Access Compliance Report

Public Rights-of-Way

(Curb Ramps)

Intersection ID: 45501	Main Street: BUGGY_HORSE_RD	Cross Street: CAPTAIN_ARDREY_RD	Location: W
ADA ID: A7FA8E33AC72	Ramp Type: PerpDiag	Initial Pass/Fail: Fail	Overall Compliance: No
Severity Score: 42.5			
Codes/Mitigation Info/Possible Solution		Field Measurements/Component Compliance

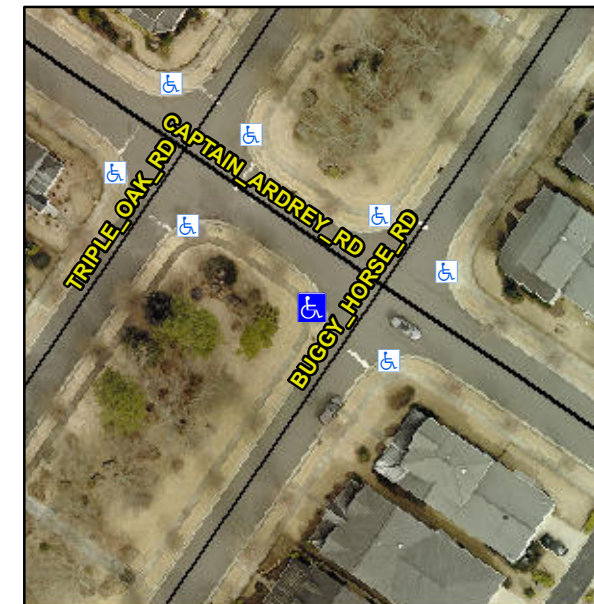
Not Found, R304.5.1, R304.2.2, R304.5.3

Compliance	Description	Data	Compliance	Description	Data
N/A	Ramp Length (in)	71.0	No	Ramp Slope (%)	10.0
No	Ramp Width (in)	35.0	No	Ramp XSlope (%)	5.2
N/A	Flare Type LT	N/A	N/A	Flare Type RT	N/A
N/A	Flare Slope LT (%)	N/A	N/A	Flare Slope RT (%)	N/A
N/A	Flare Traversable LT?	N/A	N/A	Flare Traversable RT?	N/A
N/A	Landing Length (in)	N/A	N/A	DWS Provided?	N/A
N/A	Landing Width (in)	N/A	N/A	DWS Contrast?	N/A
N/A	Landing Slope (%)	N/A	N/A	DWS Length (in)	N/A
N/A	Landing X Slope (%)	N/A	N/A	DWS Full Width?	N/A
N/A	Landing Curb? (Y/N)	N/A	N/A	DWS Offset (in)	N/A
N/A	Shared Landing?	N/A			
N/A	Gutter Ponding?	N/A	N/A	Gutter Slope (%)	N/A
N/A	Gutter Lip Ht (in)	N/A	N/A	Gutter X Slope (%)	N/A
N/A	Painted X Walk1?	No	N/A	Painted X Walk2?	No
	X Walk 1 Direction	To SE		X Walk 2 Direction	To NE
N/A	X Walk 1 Width (in)	N/A	N/A	X Walk 2 Width (in)	N/A
	X Walk 1 Slope (%)	2.3		X Walk 2 Slope (%)	3.0
	X Walk 1 X Slope (%)	0.9		X Walk 2 X Slope (%)	4.8

Remove & Replace Curb Ramp With Two New Directional Ramps or Equivalent.
